Cecil County, MD
LIDAR Review – 2005

Prepared by:
Dewberry & Davis LLC for Spatial Systems Associates
9/28/2005

Figure 5 – RMSE by specific land cover type.

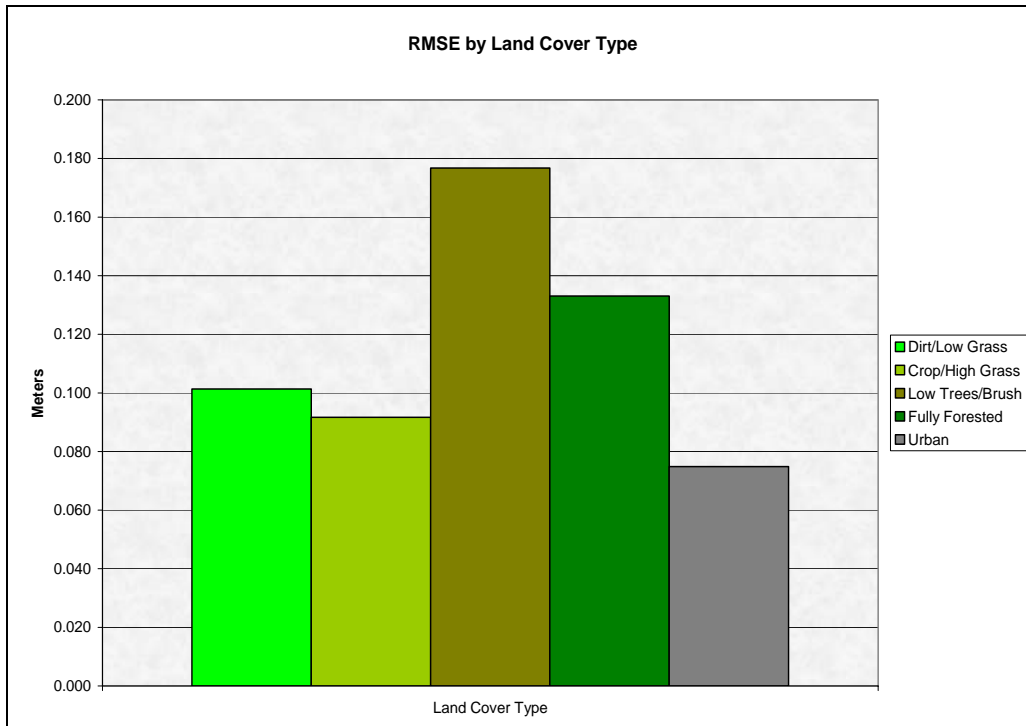
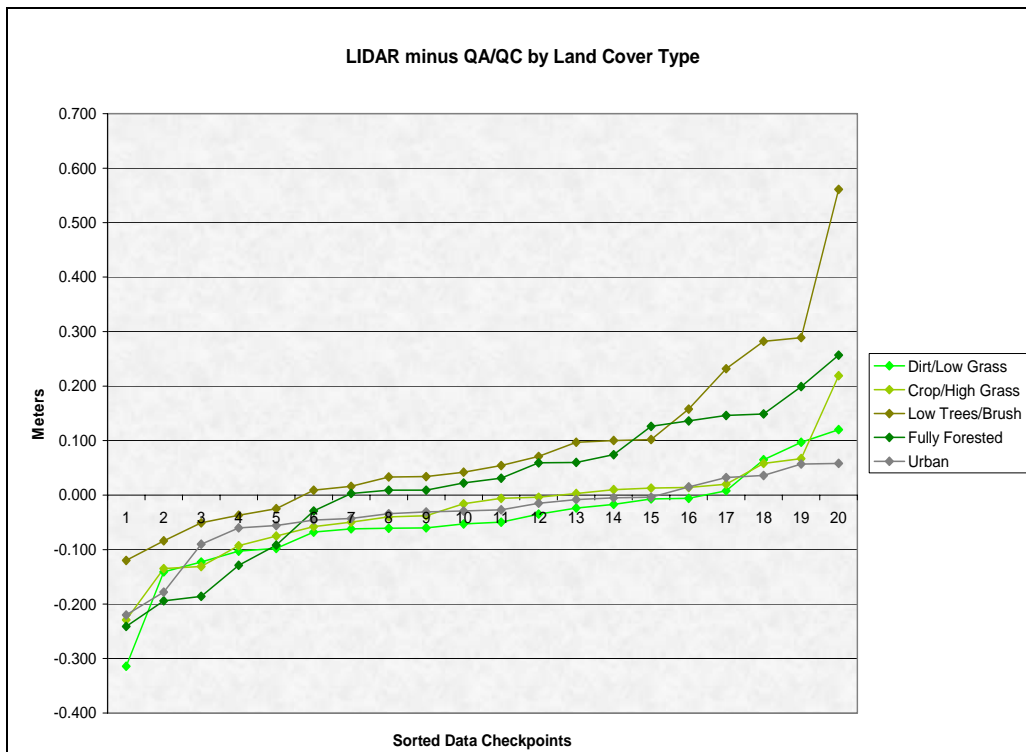
Table 2 illustrates that all of the combined checkpoints easily meet the RMSE criteria of 0.185 m and the data has excellent vertical accuracy.

Figure 5 & Figure 6 graphically illustrate the RMSE by land cover category and the elevation differences (delta) between the LIDAR compared to that of the survey QA/QC checkpoints.

Figure 9 - Aerial color-infrared photograph of area illustrating bridge locations (BJ138b61).

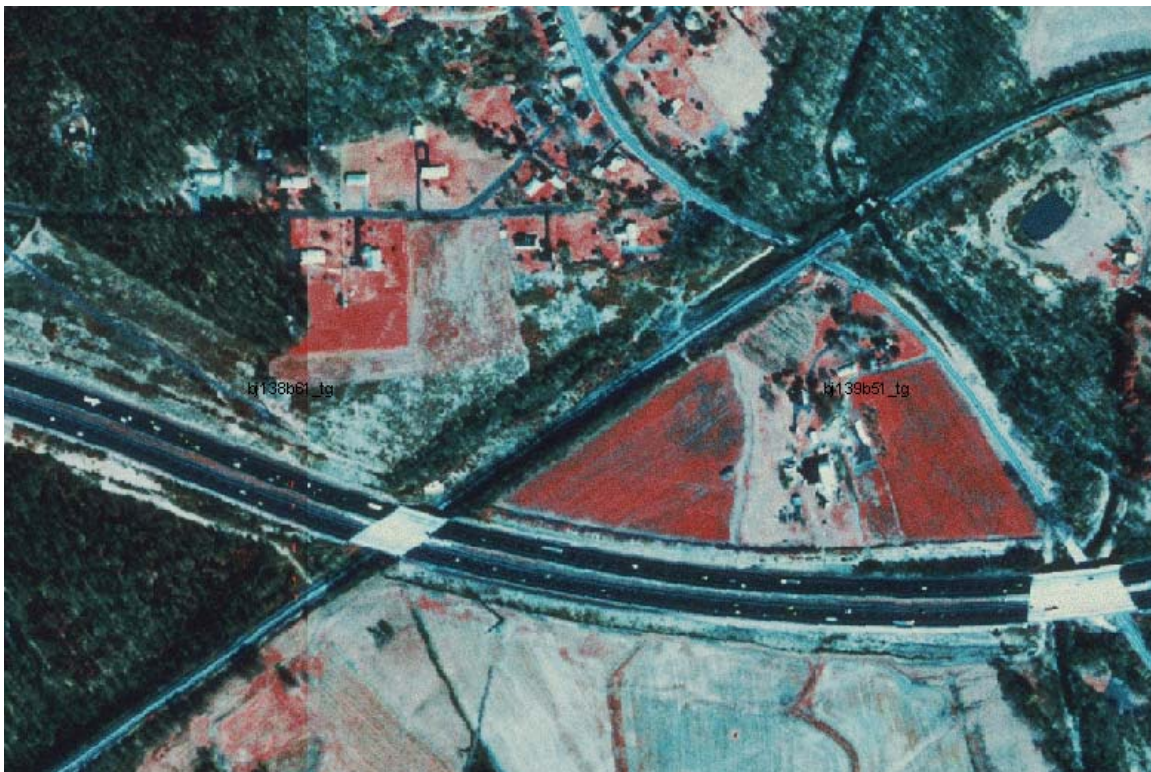
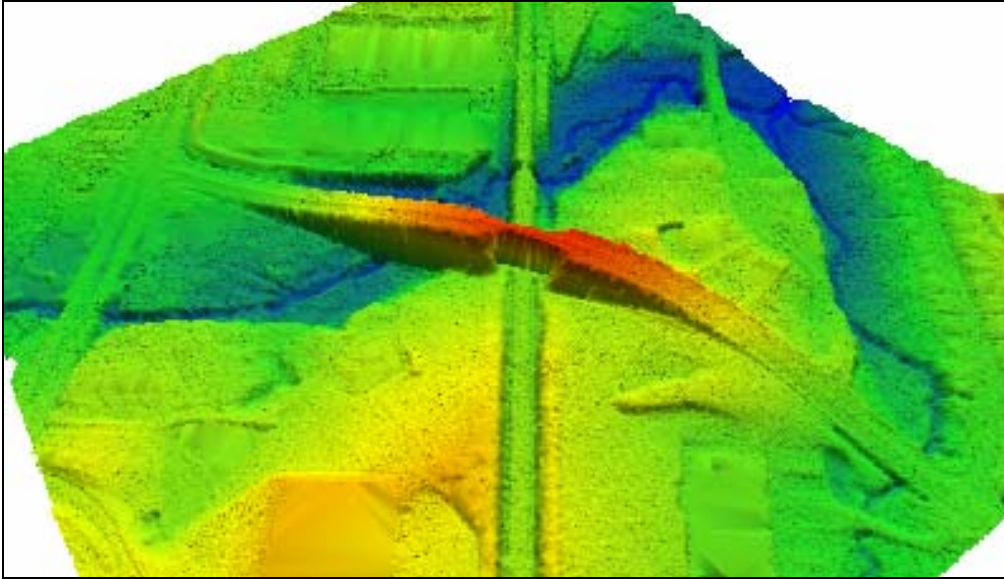
As mentioned previously, the need for having bridges maintained or removed from the data is based on the need and application of the data. Hydrologists may want them removed, transportation engineers may want them to stay and hydraulic engineers may want the bridge abutments to stay, but the deck removed. However this data has bridges that are in, or out, or have portions of the bridge deck removed. Figure 8 and Figure 9 illustrate this issue. In the northeast quadrant two bridges have been removed. However bridges in the southwest and southeast only partially are removed. Figure 10 illustrates a 3-D view of a bridge with the same issue. There are many examples of inconsistent bridge editing throughout this project.

Figure 8 - TIN Grid and Hillshade illustrating inconsistent bridge editing (BJ138b61).

Figure 10 - 3-D view of bridge editing issue.

From a qualitative perspective, the data are clean without being too clean (over-smoothed), with only a few manmade structures that were not removed during the bare-earth processing. Bridge editing for hydro-enforcement should be performed in a consistent manner. Furthermore Dewberry recommends that the zero elevations be reviewed to determine elevations that should be legitimately below zero relative to NAVD88 vertical datum.

Figure 11 - Quarry with a minimum elevation of 0.00 meters.

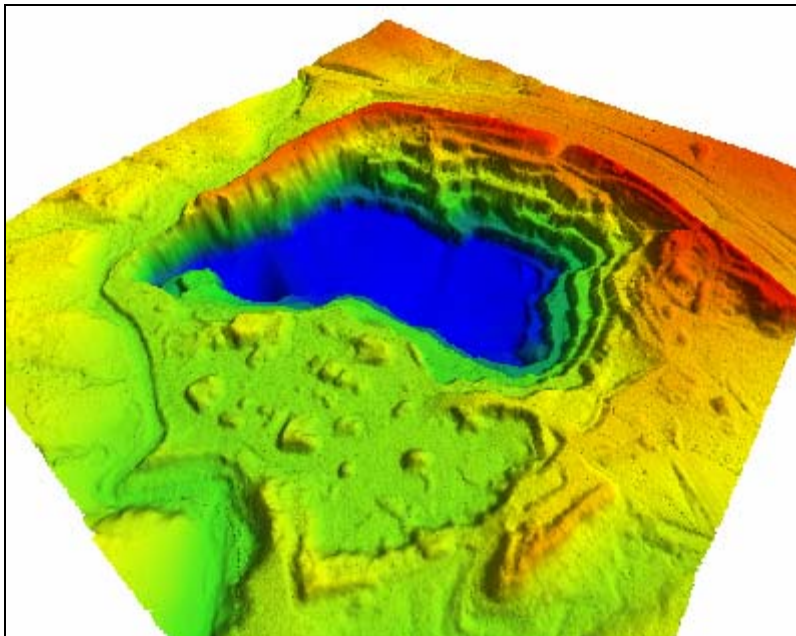
As mentioned in the verification process, many tiles have a minimum elevation of zero meters. Since this is a coastal community, it is conceivable that some elevations can be less than the zero meters in NAVD88. Figure 11 illustrates a quarry where the floor elevation is exactly zero meters. We believe that this quarry, as well as other areas, could be less than zero.

Figure 12 - Potential artifact highlighted within the circle.

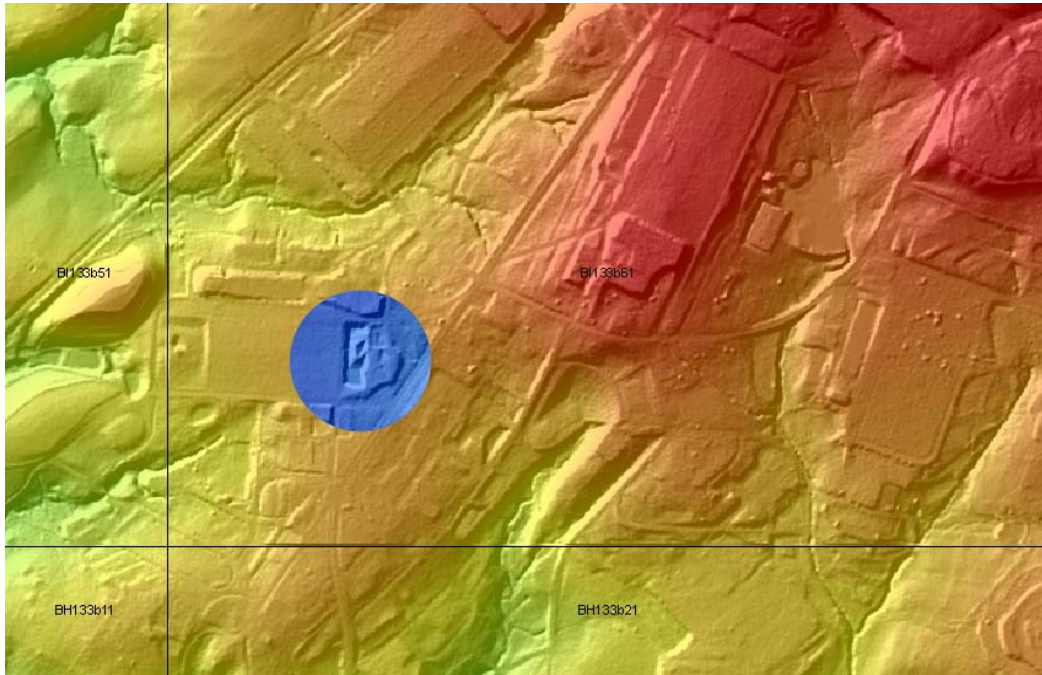
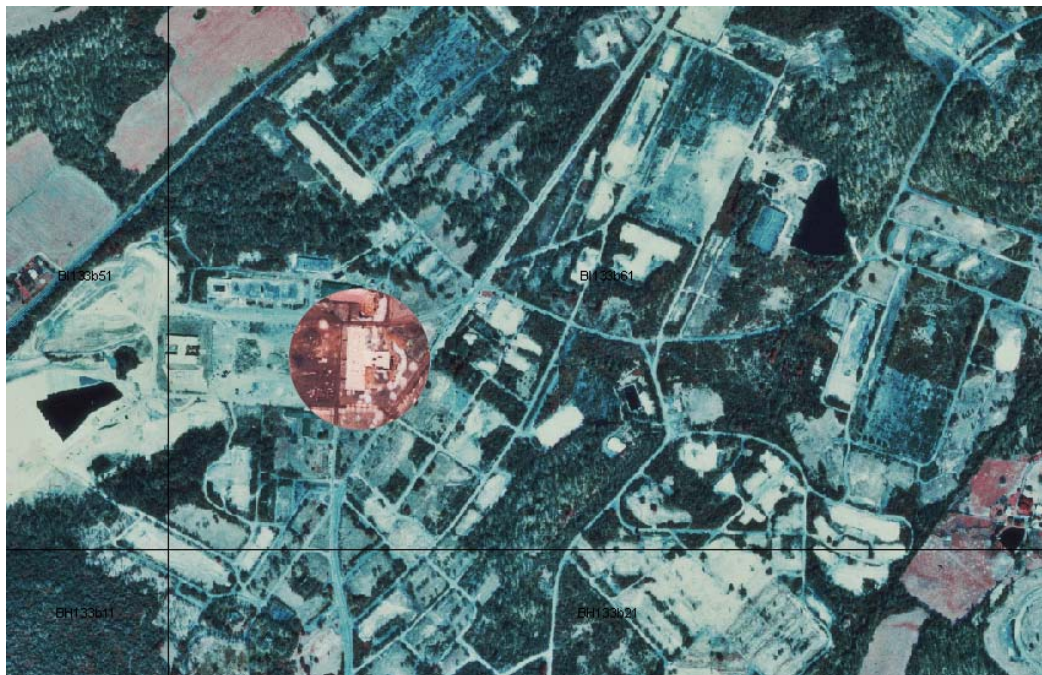
Figure 12 and Figure 13 illustrates show one of several buildings that remain after the post processing to remove building and vegetation.

Figure 13 - Potential artifact highlighted within the circle

Figure 14 - Potential artifact with associated profile for both the Tin GRID/Hillshade and a CIR photograph.

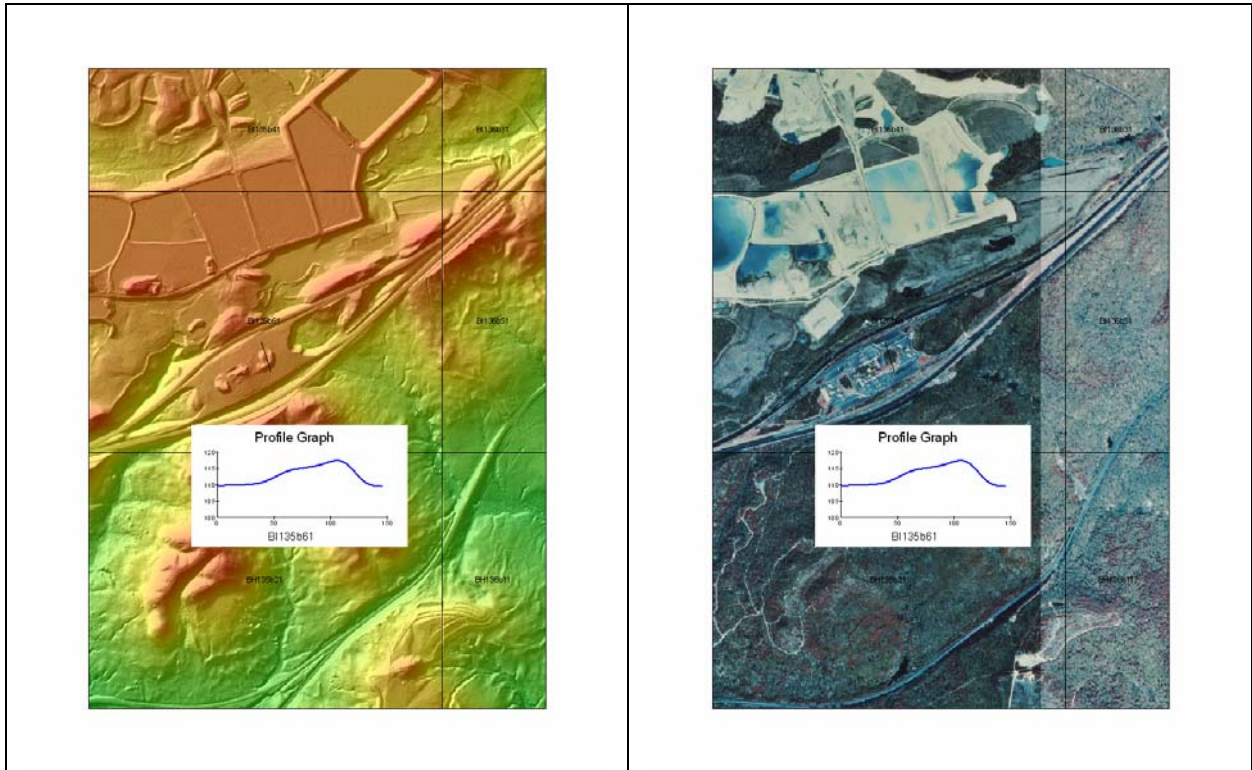
Figure 14 illustrates a rest stop along the highway that may have a large artifact consisting of vegetation beside the structure. The profile illustrates a change in elevation of over 4 meters.

Figure 17 – Tin Grid/Hillshade with “noise” within the arrow area.

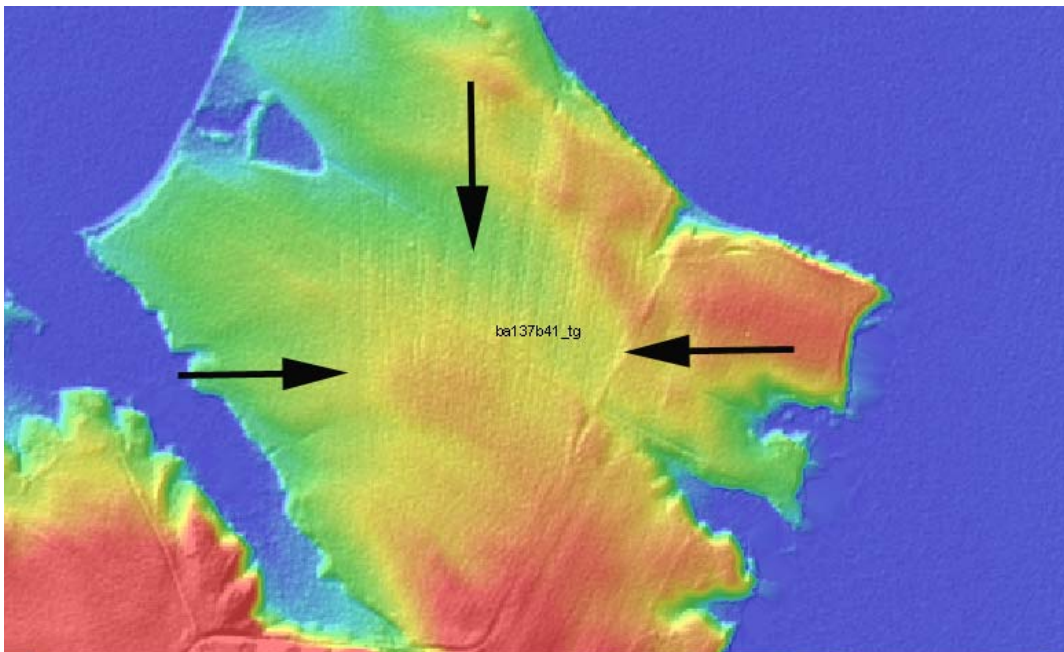
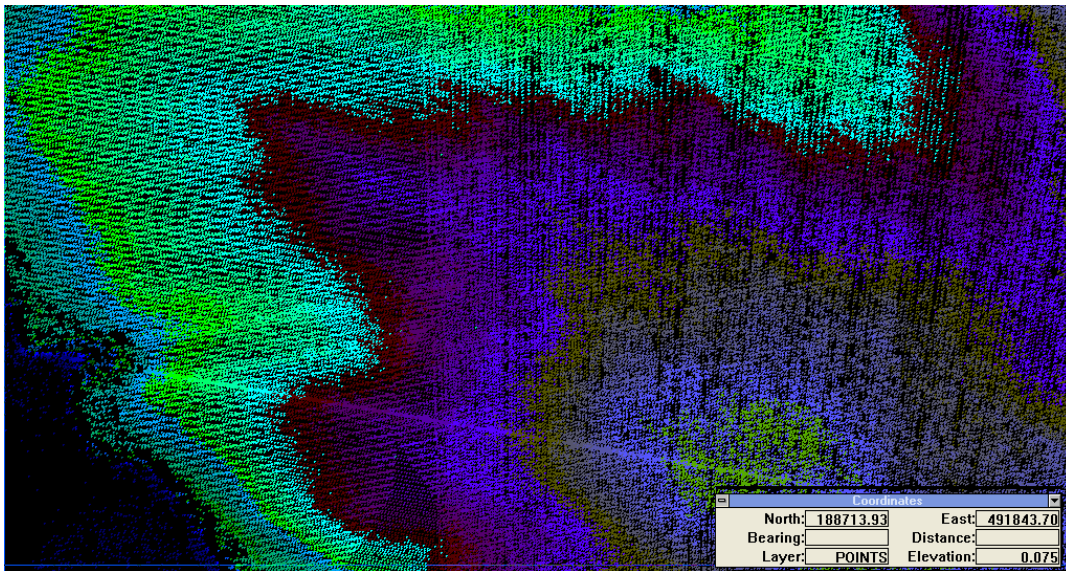
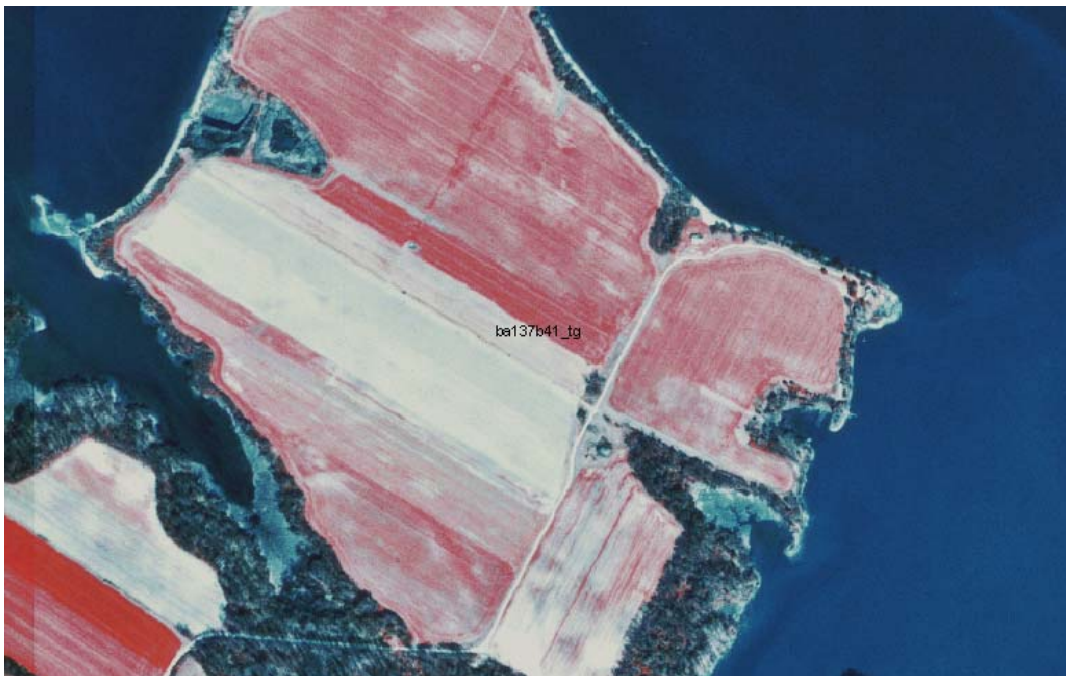
Figure 17 to Figure 19 illustrate “noisy data.” Noisy data is data within specification but showing a high variance in the elevations relative to each other. This particular area consists of flight lines that are flown perpendicular to each other. On the left side of Figure 18, the flight line was flown north-south whereas the right side of the image has lines north-south and east-west. The difference between these two datasets are approximately 0.15 meters.

Figure 18 – Scan lines, note the right side of the image has flight lines that are flown perpendicular to each other.

Figure 19 – CIR photo of area with noisy data.

Figure 20 - Legitimate feature illustrated by Tin Grid/Hillshade and intensity image.

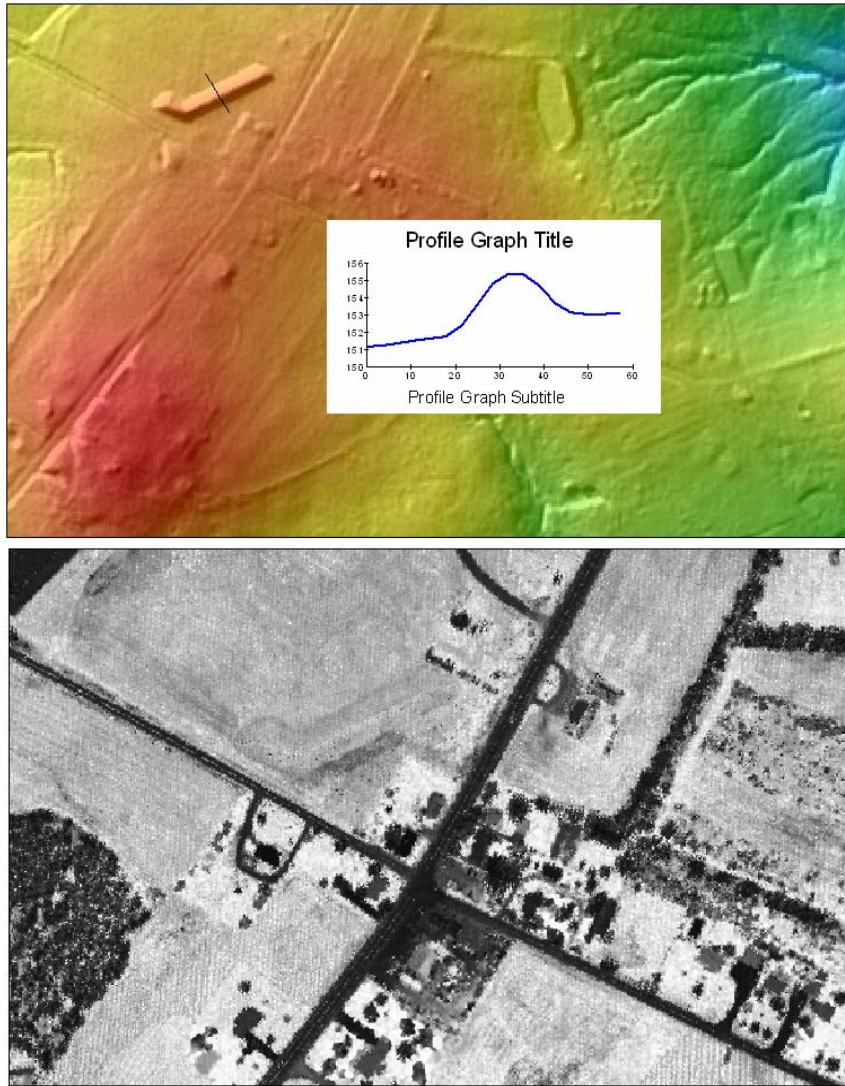
Figure 20 illustrates what appears to be an artifact nearly five meters tall based on the shape and elevation. However by using the intensity imagery, the feature in question is clearly identifiable and its texture is similar to the surrounding area.

Figure 21 – Plowed Field and forest floor from LIDAR

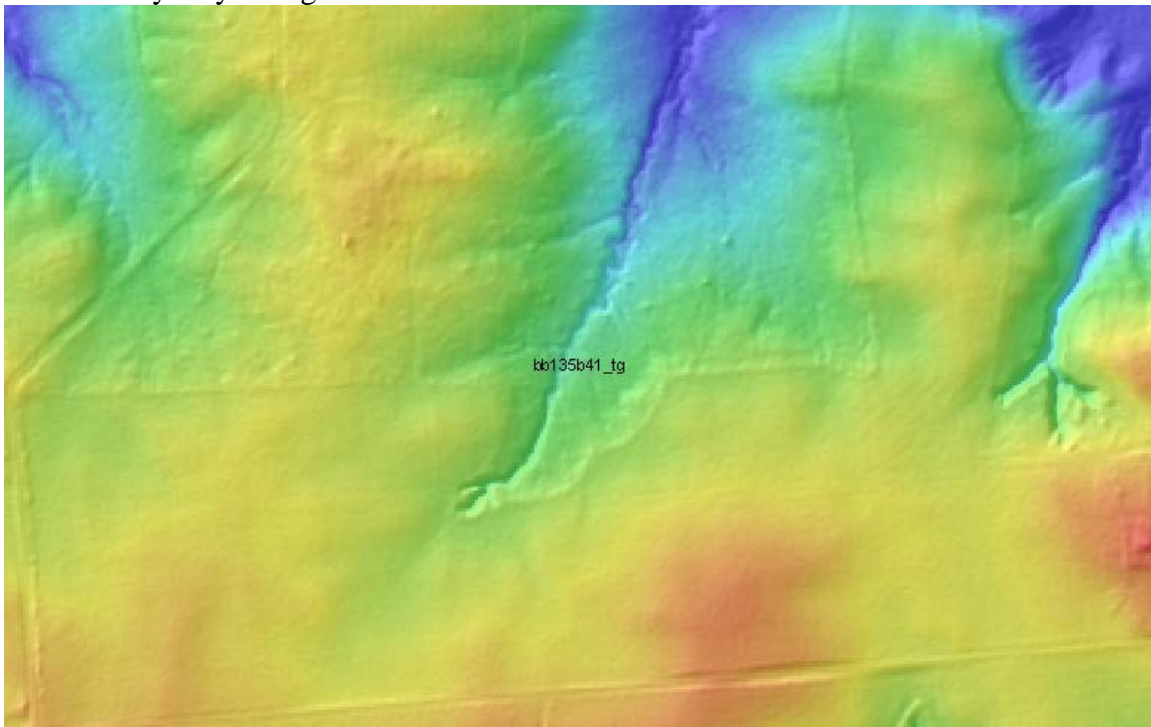
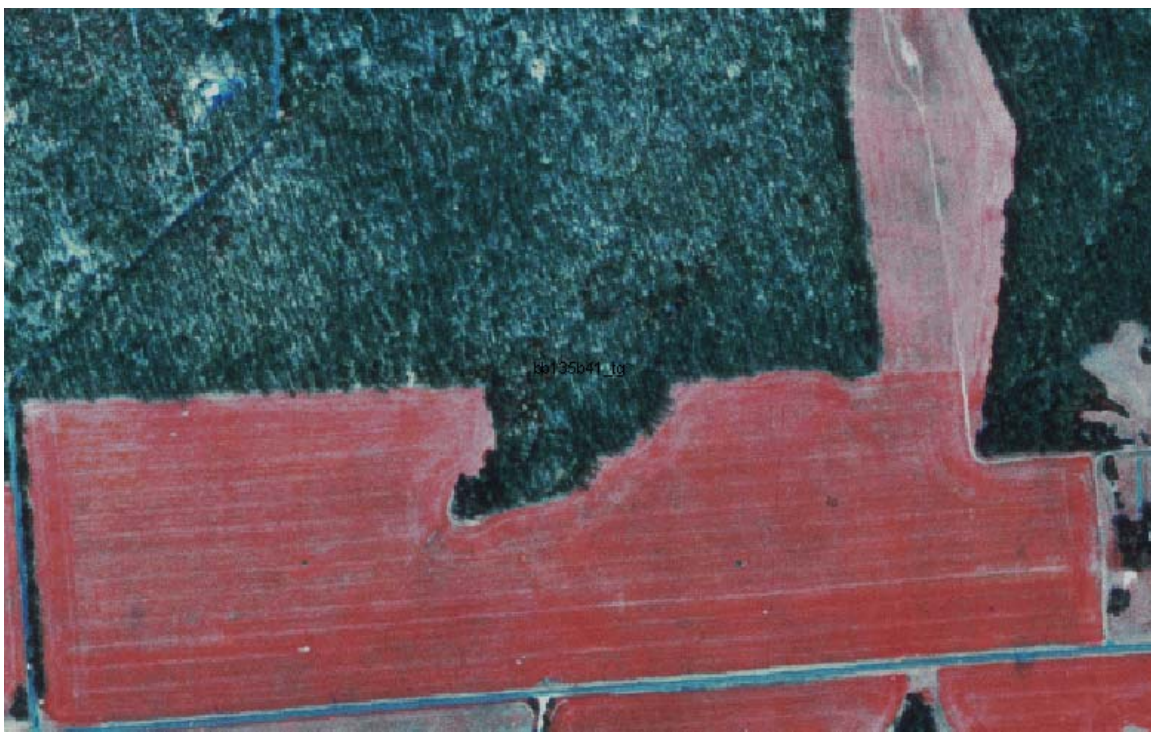
Figure 21 and Figure 22 illustrate what appears to be noisy data; however the photo shows the smoothness is from a plowed field and the roughness is an area within a forest. These are shown as to not misconstrue noisier terrain values with errors in the LIDAR because they may be legitimate features.
